- 2. Christensen Gardens; KPB File 2025-061**
Mullikin Surveys / Hough
Location: Hough Road off East End Road
City of Homer

**ITEM #2 - PRELIMINARY PLAT
Christensen Gardens**

KPB File No.	2025-061
Plat Committee Meeting:	August 11, 2025
Applicant / Owner:	Michael and Shila Hough of Homer, Alaska
Surveyor:	Christopher Mullikin / Mullikin Surveys, LLC
General Location:	Hough Road, Craftsman Road and near milepost 1.5 East End Road

TO: Homer Advisory Planning Commission
FROM: Ryan Foster, City Planner
DATE: May 21, 2025
SUBJECT: Christensen Gardens Preliminary Plat

CHRISTENSEN GARDENS

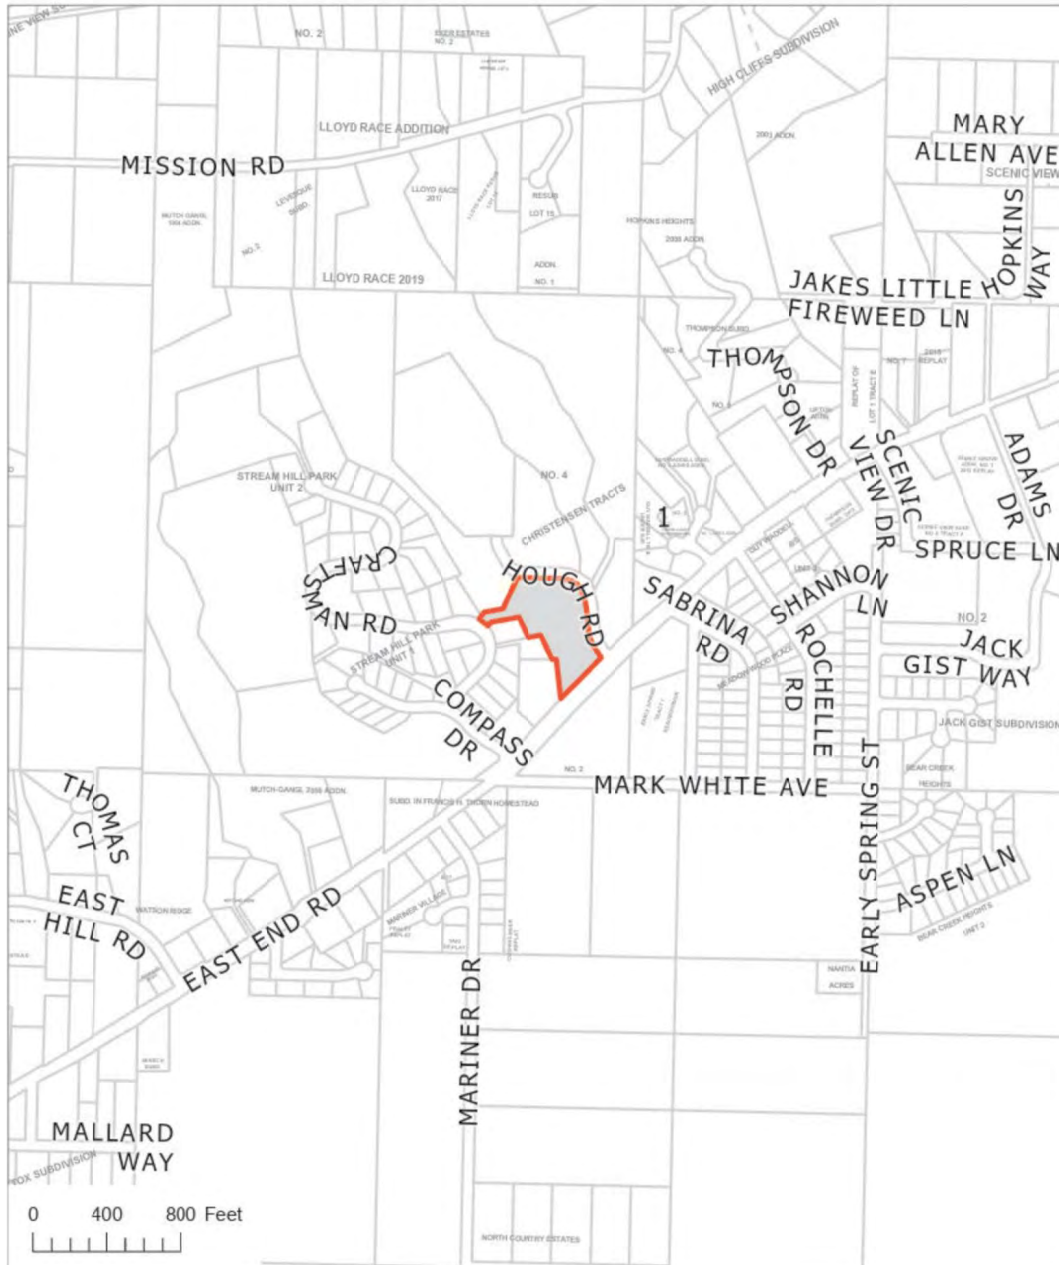
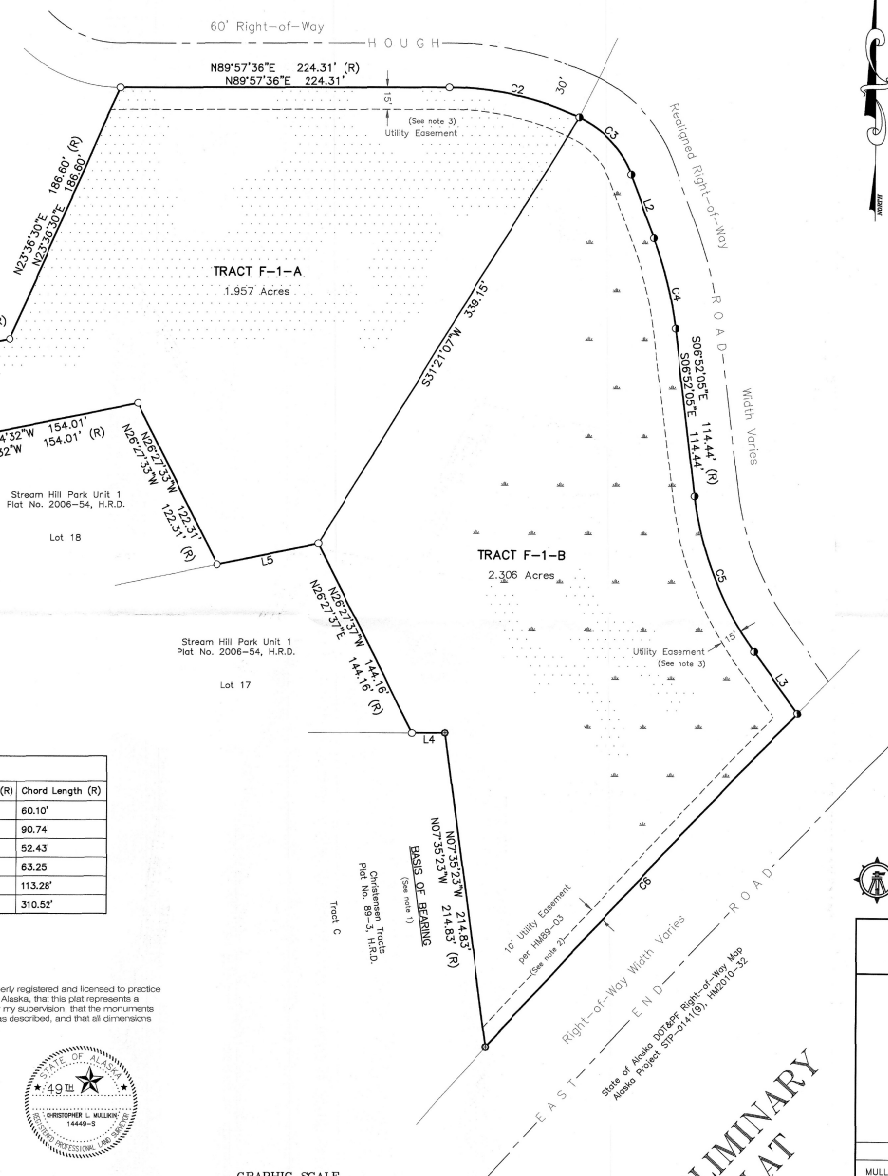
There is a 10 foot utility easement at plat note 2, which the City of Homer has requested to be removed. Staff recommends the note be removed and plat note 3 be modified to show the 15' underground utility is being carried forward from plat HM2023-14 and it parent plats.

Christensen Tracts (Plat HM 89-3) granted a 20-foot utility easement centered on existing powerlines. **Staff recommends** the surveyor confirm if there are existing powerlines within the subject area. If so, carry forward the plat note.

Depict the creeks crossing the plat and show the 20' bank easements

Carry forward plat note 12 from HM2023-14.

Revise the easement along East End Road to 15'

Remove setback line from legend per City of Homer recommendation

Darken 20% grade shading or change designation method.

- o Please include City of Homer within the legal description
- o Please modify the KPB file number to 2025-061
- o Consider renaming plat to include the majority of the parent plats name: Christensen Tracts Garden Addition. City Approval of new name will be required.

- o Add depiction of creek/drainage easement
- o Verify existing powerlines/20-foot utility easement.

- Add labels and lot lines for all lots across from Hugh Road ROW
- Modify the label for the west parcel: Tract B HM 2008-48

- Creek depicted on parent plats HM 89-3 and HM 2008-48. Locate and accurately depict creek.

- Modify the owners' names to match how they're listed in the title block and Certificate to Plat

- Modify the plat approval date to August 11, 2025
-

Staff Response: The plat does not meet these requirements. The utility easement shown on the plat along East End Road is identified as 10 feet. In contrast, 15-feet is designated for all other utility easements along Hough Road and Craftsman Road. According to Note 2 on the plat, the surveyor identifies Tract F-1-B—which fronts the right-of-way of East End Road—as having a 10-foot utility easement. However, in accordance with HCC 22.101.051, staff recommends that the surveyor remove Note 2 and revise the utility easement along East End Road to reflect the required 15 feet.

Staff Response: The plat does not meet the specified requirements. Drainage easements are present on both Tracts F-1-A and F-1-B. According to the plat, notes 6 and 7 reference the presence of creeks and drainages; however, their locations are not illustrated. Staff recommends that the surveyor clearly indicate the locations of all existing creeks and drainage features as referenced in the notes. Additionally, staff recommends that the plat either remove "setback line" from the legend, as no setbacks are illustrated, or include the appropriate setback illustrations as referenced in the legend.

Staff Response: The plat does not meet these requirements, as it lacks any indication of the status of the adjacent lands to the east, fronting Hough Road. Staff recommends that information regarding the status of these lands eastward across Hough Road be included on the plat. Additionally, staff advises that the lot number of the adjacent land to the northwest of Tract F-1-A be revised to reflect the record and be labeled as "Tract B" instead of "Lot 30."

1. In accordance with HCC 22.101.051, staff recommends that the surveyor remove Note 2 and revise the utility easement along East End Road to reflect the required 15 feet.
2. Staff recommends that the surveyor clearly indicate the locations of all existing creeks and drainage features as referenced in the notes.
3. Staff recommends that the surveyor either remove "setback line" from the plat's legend, as no setbacks are illustrated, or illustrate the appropriate setbacks as referenced in Note 6.
4. Staff recommends that information regarding the status of lands across Hough Road to the east be included on the plat.
5. Staff recommends that the lot number of the adjacent land to the northwest of Tract F-1-A be revised to reflect the record and read as "Tract B" instead of "Lot 30."
